**TOWN OF CARMEL**  
**PLANNING BOARD**

**PLANNING BOARD AGENDA**  
**JUNE 13, 2018 – 7:00 P.M.**

**Amended Site Plan Application for Alexandrion Group/Hinkley Holdings, LLC  
Tm#55.10-1-1, 3, and 55.6-1-53**

The following memorandum addresses the Amended Site Plan application submitted by Alexandrion Holdings, Ltd., for property located at 39 Seminary Hill Road, Carmel. The material reviewed consisted of a Project Description, Site Plan application form, Site Plan Completeness Certification, Short Environmental Assessment Form, and the following plans prepared by Epstein Architecture, dated March 29, 2018, last revised May 2, 2018:

**OVERALL TRUCK MANEUVERING PLAN**

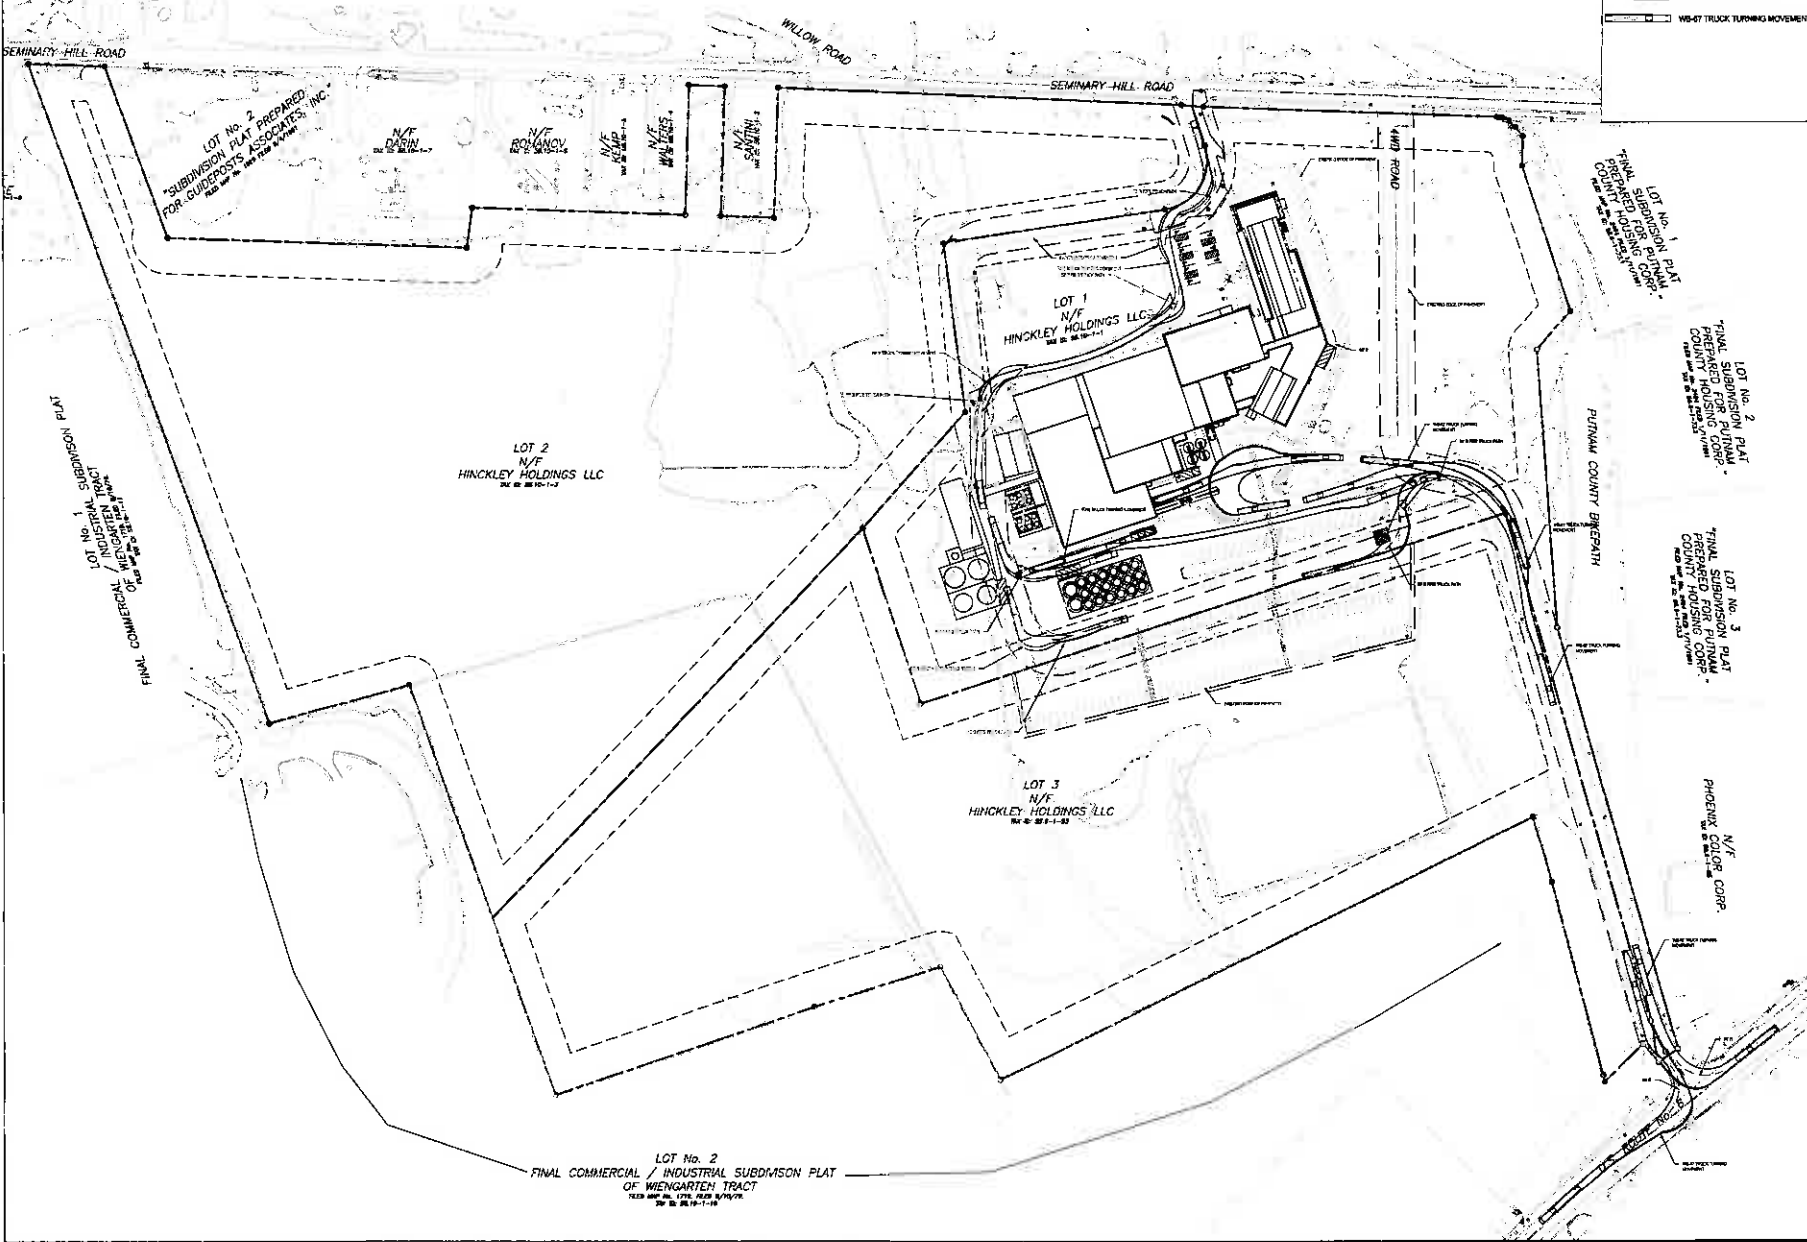
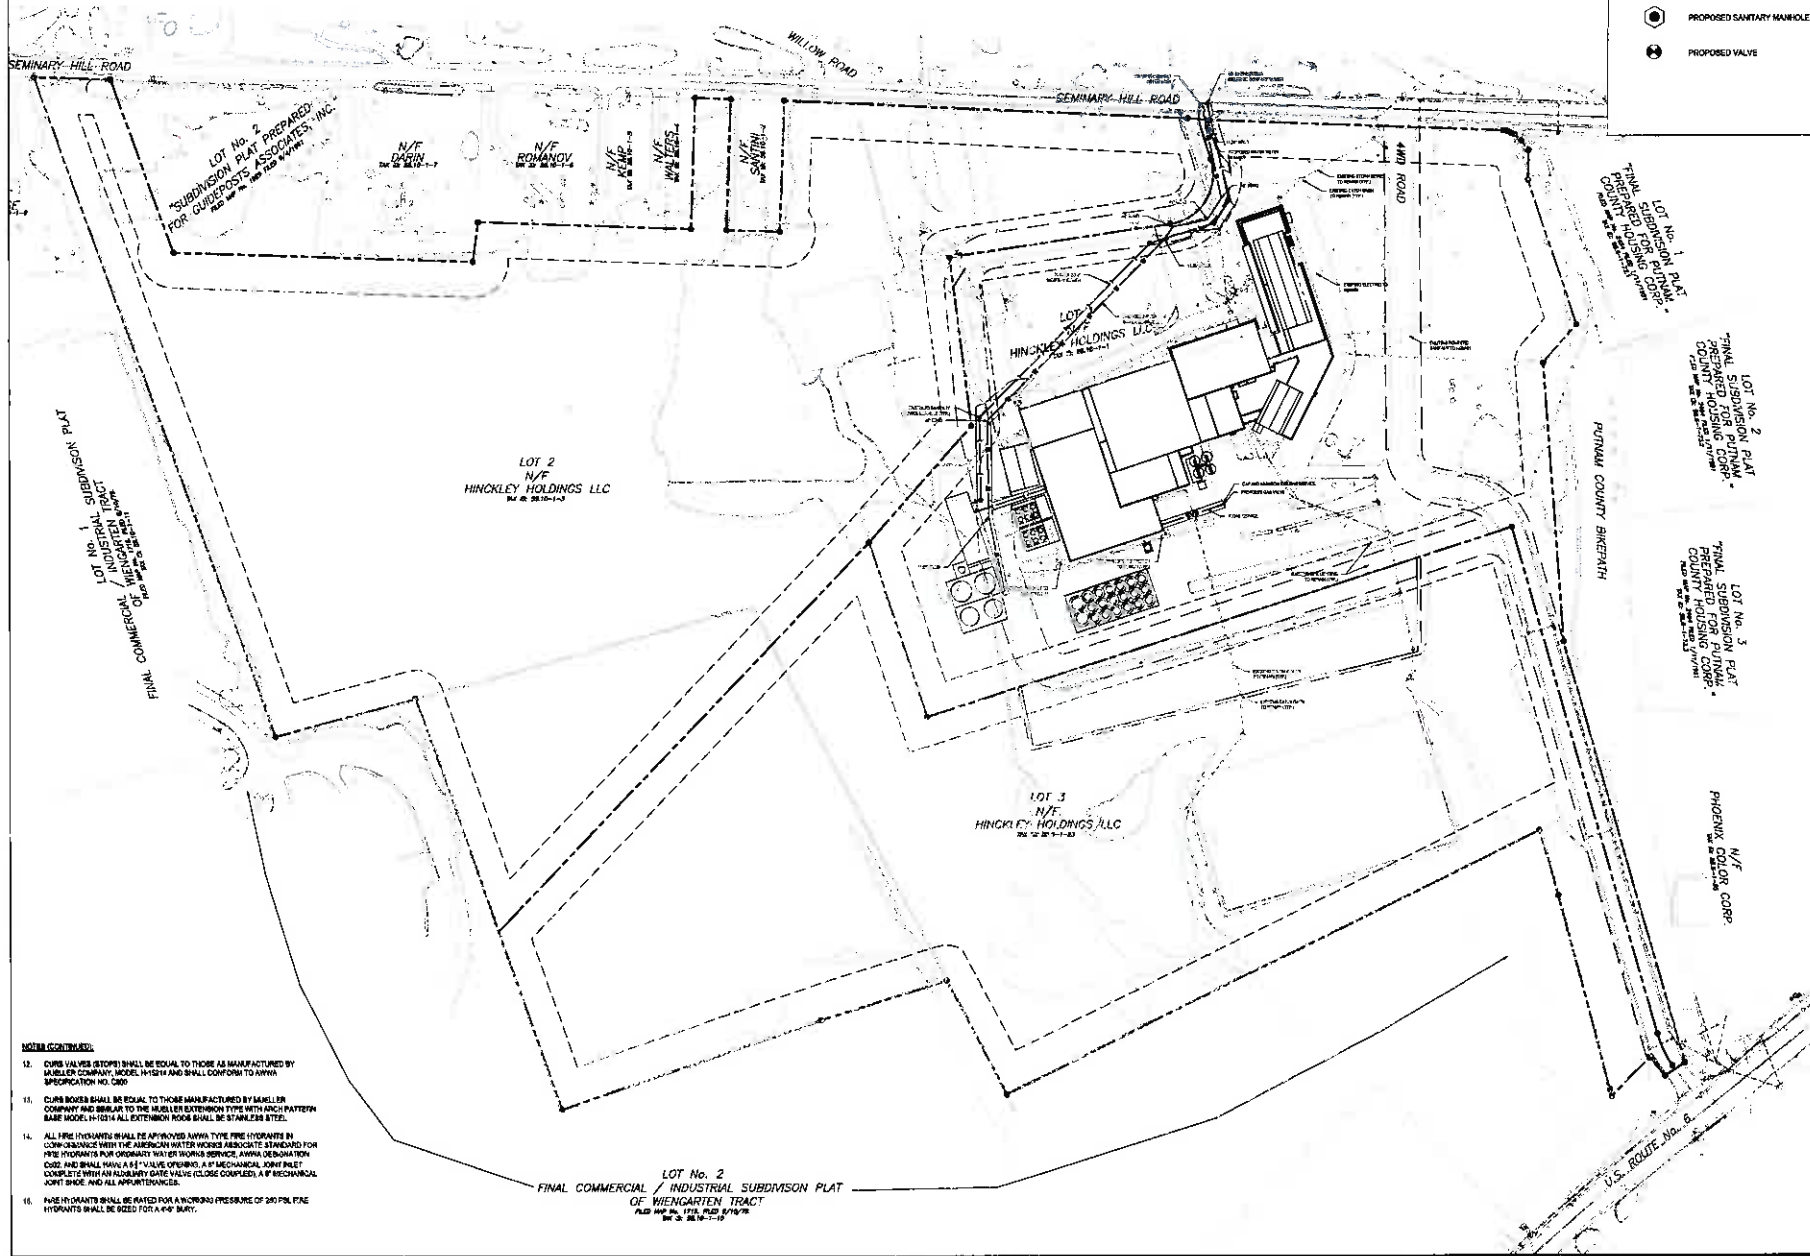
13. Graphic representation of vehicle movements through the site should be provided to illustrate that sufficient space exists to maneuver all types of vehicles anticipated at the site.

14. All turning radii for the site should be graphically provided.

15. Available sight distances at each driveway location should be specified on plan. Any clearing along the edge of the roadway R.O.W. that may be necessary to assure appropriate sight distances are provided, should be identified.

**Epstein Response:** A vehicular maneuvering plan will be provided.

**Epstein Response:** All turning radii will be depicted and labelled on the plan.

**Epstein Response:** The required sight distances will be shown on the site plan and calculations are provided.
